West Wyalong Solar Farm Modification 1

Road upgrades
State Significant Development Modification Assessment
(SSD 9504 MOD 1)

September 2021

Published by the NSW Department of Planning, Industry and Environment

Figure 2 | Approved road upgrades and site access

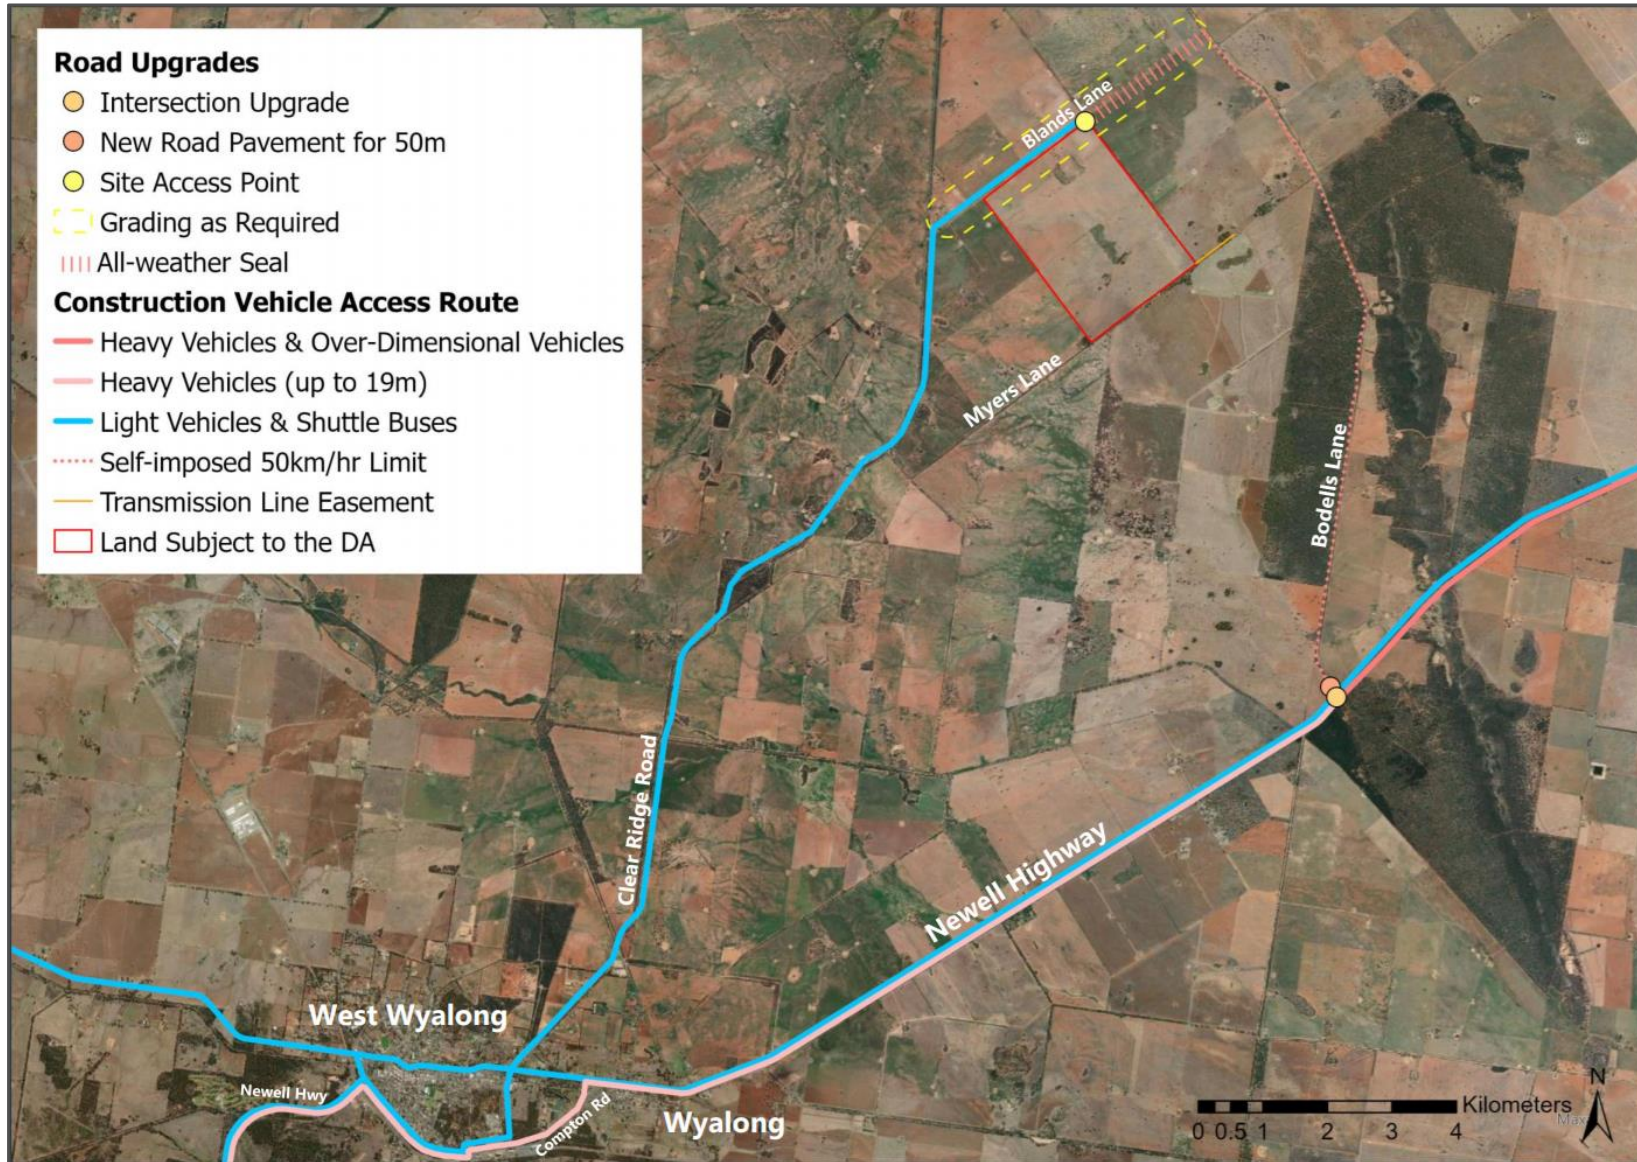
The existing development consent requires road upgrades to be undertaken on Blands Lane between Bodells Lane and Clear Ridge Road, including grading and an all-weather seal. Initially, the modification application sought to reduce the scope of the road upgrade to be between Bodells Lane and the site access point and remove the requirement to include grading and an all-weather seal.

The amended treatment proposed for Blands Lane is considered appropriate as it provides a graded and sealed access route for heavy vehicles approaching from the east and graded access for light vehicles approaching from the west.

The proposed modification seeks to remove the requirement to include a BAL treatment at the intersection of Bodells Lane and the Newell Highway, and instead require road upgrades to cater for the largest vehicle accessing the site. The BAL treatment was no longer required because vehicles greater than 19 m in length would be restricted from accessing the site via the Newell Highway southwest, as per advice from TfNSW.

Road section – Blands Lane	Road upgrades – original proposal	Council concerns	Road upgrades - amended proposal
Bodells Lane to site access point	Remove requirement to include grading and an all-weather seal in upgrade	Suitability of the road treatment with regards to heavy and over-dimensional vehicle usage	Include grading and an all-weather seal as per original condition
Site access point to Clear Ridge Road	Remove requirement to upgrade	Accessibility for light vehicles and shuttle buses	Include grading but remove requirement for all-weather seal
